**OBJECTION TO PLANNING APPLICATION 2013/7646/P**

**REDEVELOPMENT OF 79 CAMDEN ROAD AND 86-100 ST PANCRAS WAY, NW1 9EU**

2 - St Pancras Way Elevation

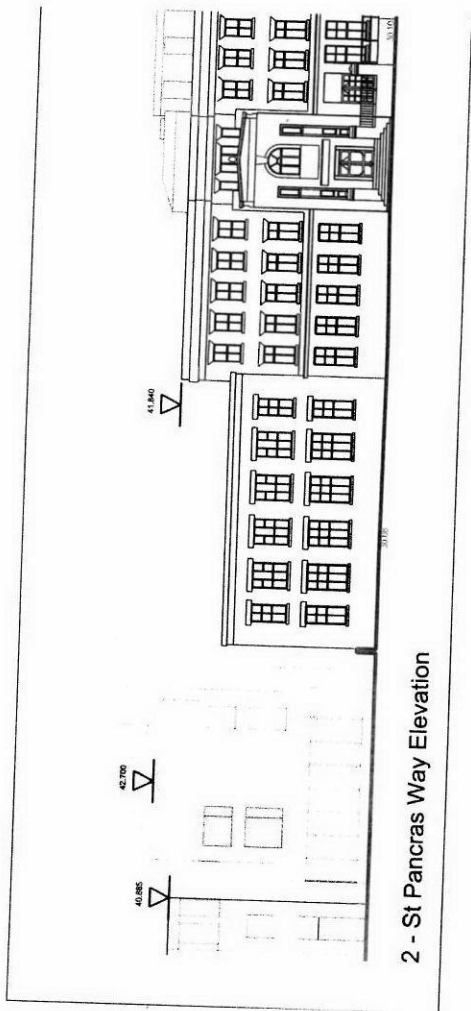
The application documents refer to these objections and they say that amendments have been made to take account of light into their own proposed flats on the northern boundary with us. However, now I have seen the drawings I am shocked to see the scale of what is proposed directly facing our windows along our southern flank versus what Barratts had been talking to us about. This is apparent not only in comparing a number of the existing and proposed elevations and sections, but the 3D illustrations in the appendices to the GIA external Daylight and Sunlight report graphically show how the proposal will dwarf our building and all of our windows on that side (attached).

It is completely inequitable that the new building should not adhere to the same angle from the boundary as our building. So acute will be the angle to the top of the building that all visible sky will be lost to our windows unless we stand right up against the pane.

We feel that the current proposal of a very much taller building than we anticipated so close to long stretches of our windows should be rejected requiring the developer to scale down the height by two floors and or increase the distance from the boundary in a more equitable arrangement.
